Accredited Standards Committee
X3, Information Processing Systems

Doc: X3T10/95-356r0
Date: November 8, 1995
Project: X3T10/0855D
Ref Doc.: ANSI X3.253:1995
Reply to: Lawrence J. Lamers

To: X3T10 Membership
From: Lawrence J. Lamers
Subject: SPI Defects and Clarifications

D.2 Cable measurement

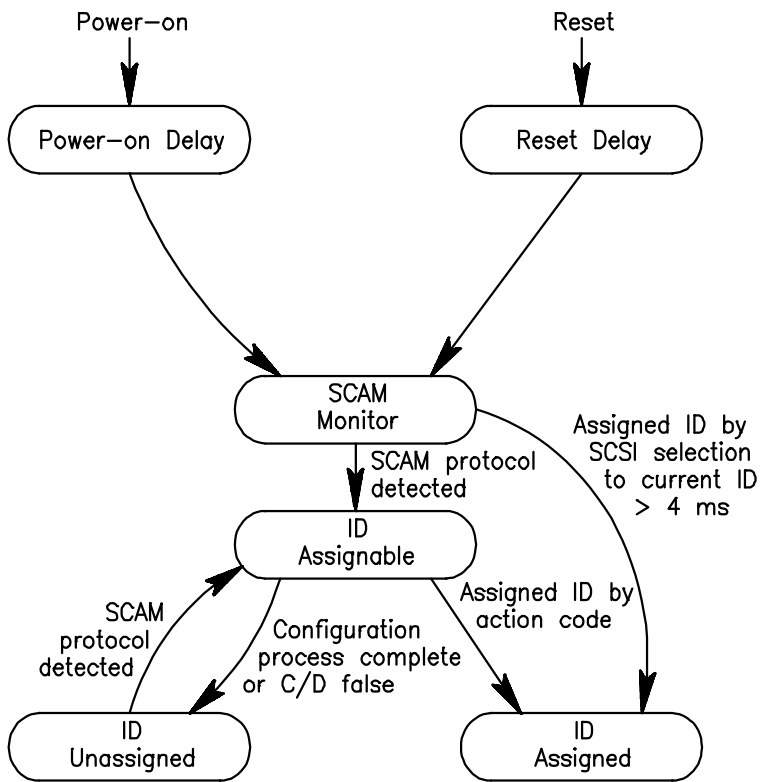
The following figure replaces Figure B.2. This figure correctly reflects the steps defined in the text.

The following figure replaces Figure B.3. This figure correctly reflects the steps defined in the text.
